**ZILKER NEIGHBORHOOD ASSOCIATION COMMENTS
TO THE PLANNING COMMISSION HEARING (27 AUG 2019)
ON 211 SOUTH LAMAR PUD REZONING**

EXHIBIT 1

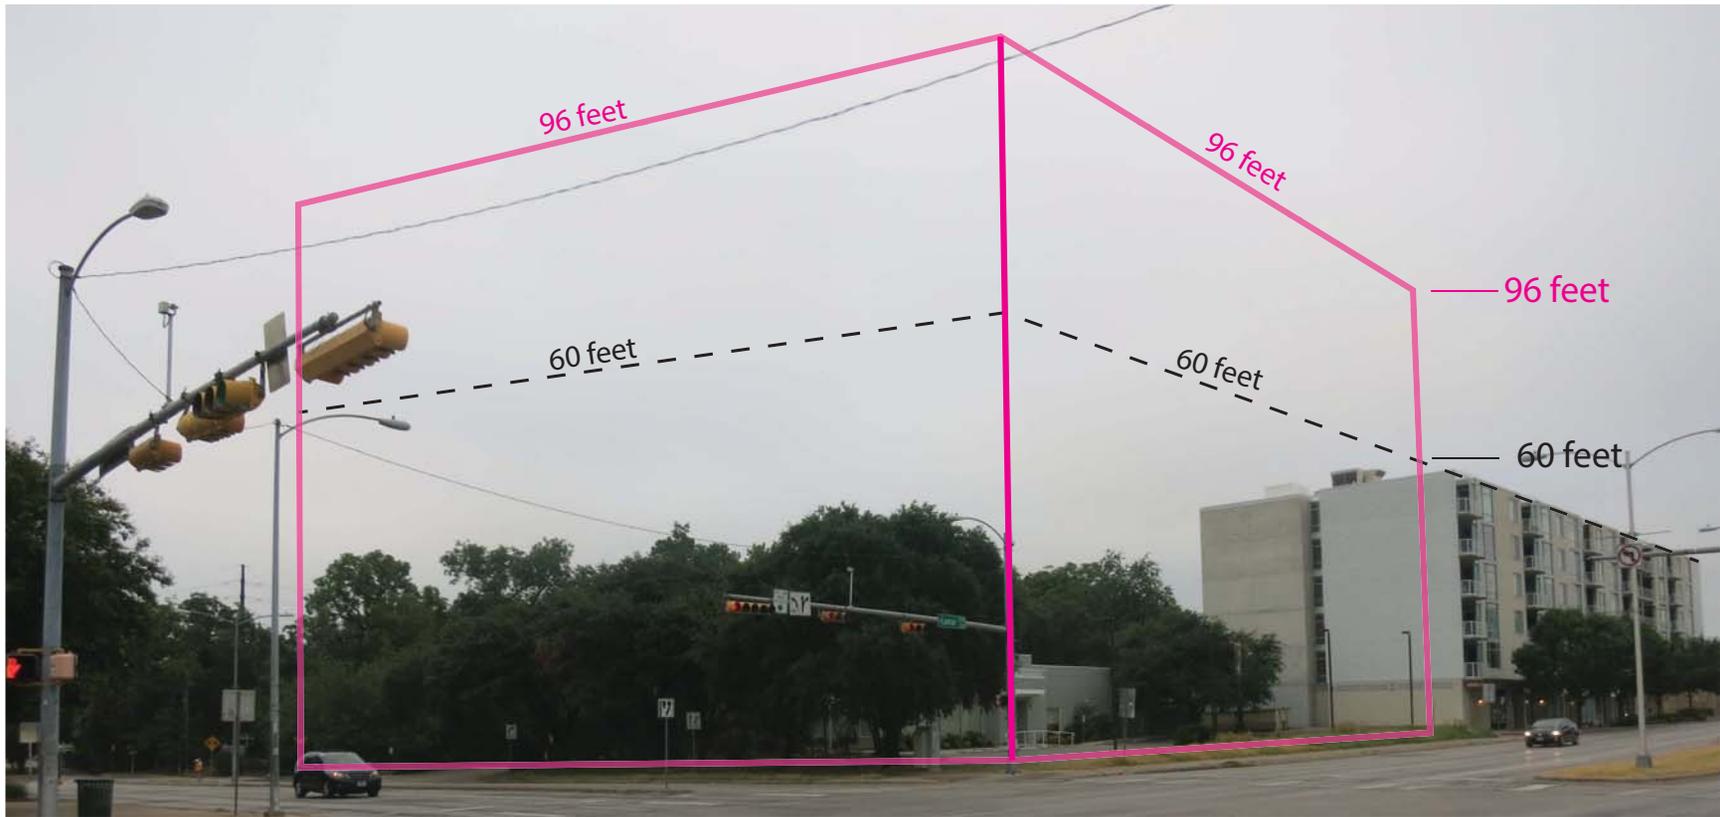
The language in the ordinance with respect to the height of the project does not seem to make sense. The following is the language in the ordinance with respect to the height:

PART 4.H.1.b.

“(i) The first building block will have a maximum height of 96 feet and will be situated (A) along the entire length of the Project's South Lamar Boulevard edge; (B) along the entire length of the Project's Riverside Drive edge; and (C) along the Project's Lee Barton Drive edge generally from the Project's Riverside Drive edge to a point no closer than 56 feet (excluding balconies) from the Project's southern property line along Lee Barton Drive”

(ii) The second building block will have a maximum height of 78 feet and will be (A) on the exterior side of the "U"; (B) situated along a portion of the Project's Riverside Drive edge (it will not extend all the way to the Project's South Lamar Boulevard edge), wrapping the Project's Riverside Drive/Lee Barton Drive comer, and extending along the

Project's Lee Barton Drive edge to a point no closer to the southern property line of the Property than the terminus of the first building block described in subpart (i) above;

Presumably the reference to "Project's southern property line along Lee Barton Drive" refers to east-west property line between the hotel project and the Paggi House which is more or less perpendicular to Lee Barton Drive (rather than "along" it). The language seems to propose two building blocks, but the second building block (86' in height) appears to be completely contained within the first building block (96' in height) as shown in Exhibit 1, so it is unclear whether there will even be a second building block. The entire project could be 96' high as we read the language.
